June 19, 2014 Draft

Water Technology Project # 13399.01

Project Description: The Traverse City Water Feature was conceived as an interactive, educational water playground for citizens and visitors to downtown Traverse City, MI. Designed and constructed during 2012/2013, the Water Feature is located in Clinch Park, a waterfront park in downtown Traverse City. Part of Clinch Park's bay front plan, the Water Feature work was part of a more general scope which included landscape areas, a concessions & bathhouse building, an accessible kayak launch, a playground, walkways, decks and civil improvements. The intent of the Water Feature is to provide an inter-active, educational water feature for the public to play in. (Photo 01) The design of the Water Feature is intended to emulate the natural water cycle. (Photo 02)

It is understood that the Water Feature opened in late 2013, and experienced multiple issues and concerns immediately. Water Technology, Inc. was engaged in early 2014 to review project documentation and to conduct a site visit for the limited purpose of commenting on issues and offering options for restoration/renovation. The scope of this review is limited to the Water

Photo 22

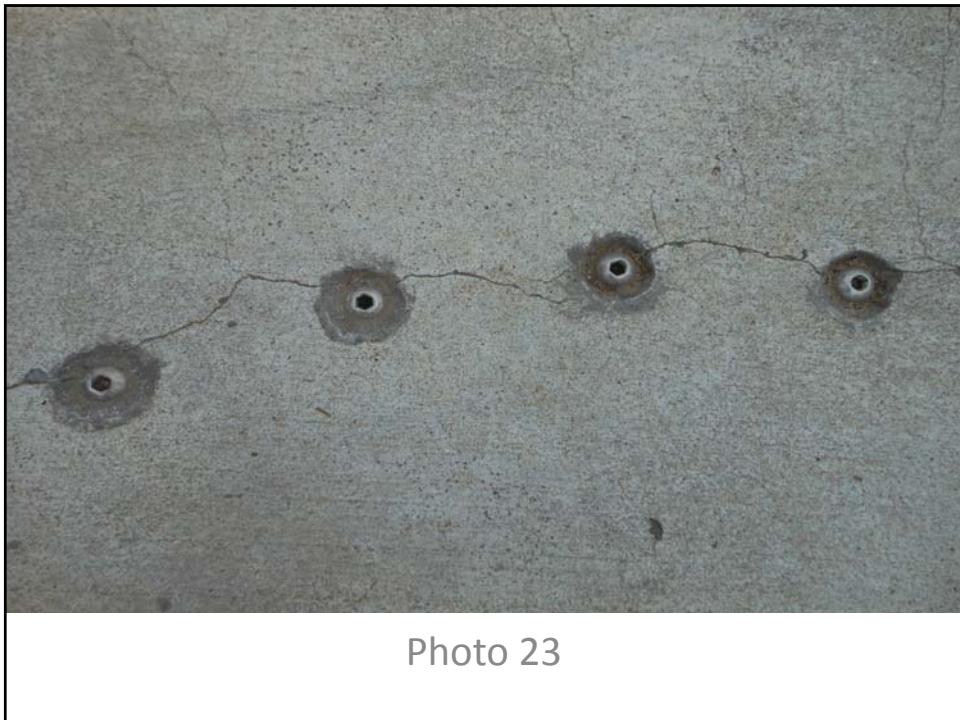
no detailing of the concrete at this feature. From the product cut-sheet, it appears that the manifold ring is 1 1/2" brass pipe, and that the nozzles are approximately ½" tall. The nozzles provided to the City appear to be standard dome head stainless steel bolts with a holes drilled in them(Photo 22).

Comments: The “water cage” or spray ring feature appears to be a fountain product adapted to an interactive spray pad. The product cut sheet shows the product installed in water, the manifold ring is shallow for a concrete installation. Detailing the installation with a control joint connecting the nozzles would have helped. Staff noted that winterization of the feature involves removing the 210 “nozzles” from the feature and replacing them with plugs. Staff further stated that some of the nozzles are very difficult to remove, as the threading of the “nozzle” goes through concrete(Photo 23).

Recommendations: Essentially this condition is the result of the wrong application of a product intended for another use. Given the project's shallow depth to the manifold and the limited spacing between nozzles, the concrete deterioration is not surprising. Winterization difficulties also highlight the fact that the product is not designed for this application. Corrective actions include removal of concrete around the rings and replacing with a joint between nozzles, re-furbishing the spray rings with a bushing that would be flush to the concrete finish, but recesses the nozzles, or placing a safety surface over the splash area of the feature to cover the concrete.

Photo 31

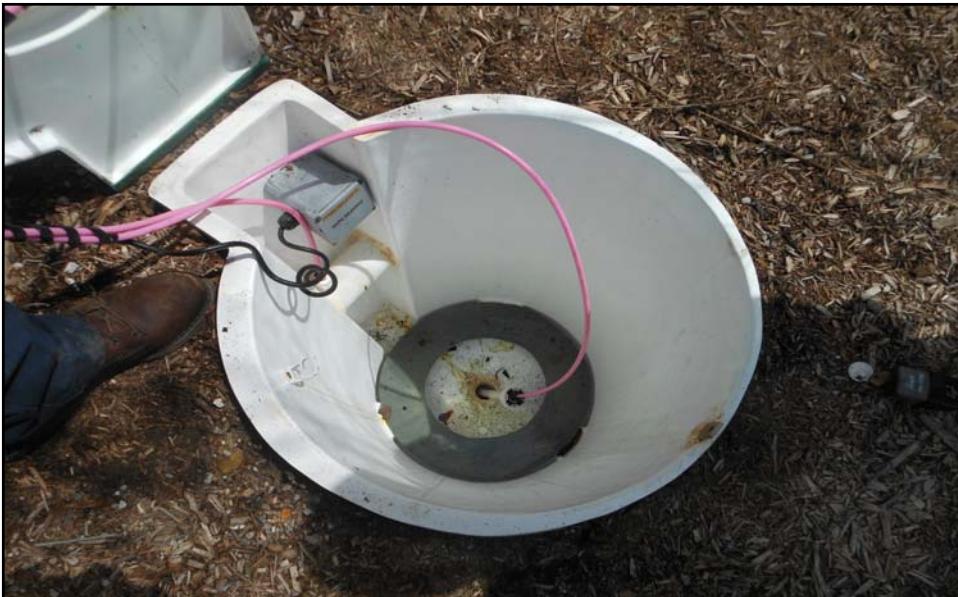
Comments: Staff expressed concern with access to the chemical tanks, both from a service standpoint and that they are exposed to park patrons. Located in a landscape area, the surrounding plantings render access to the units difficult (Photos 31 & 32). The units are accessed 3 times weekly to check chemical

Recommendations: Re-Locate chemical reservoirs to inside the mechanical room. Construct two chemical closets to house the units, vented separately to exterior. This will allow City staff to easily monitor the usage. If demand warrants, this will allow the City to easily upsize chemical capacity to a two week supply. A two week supply is WTI's design standard.
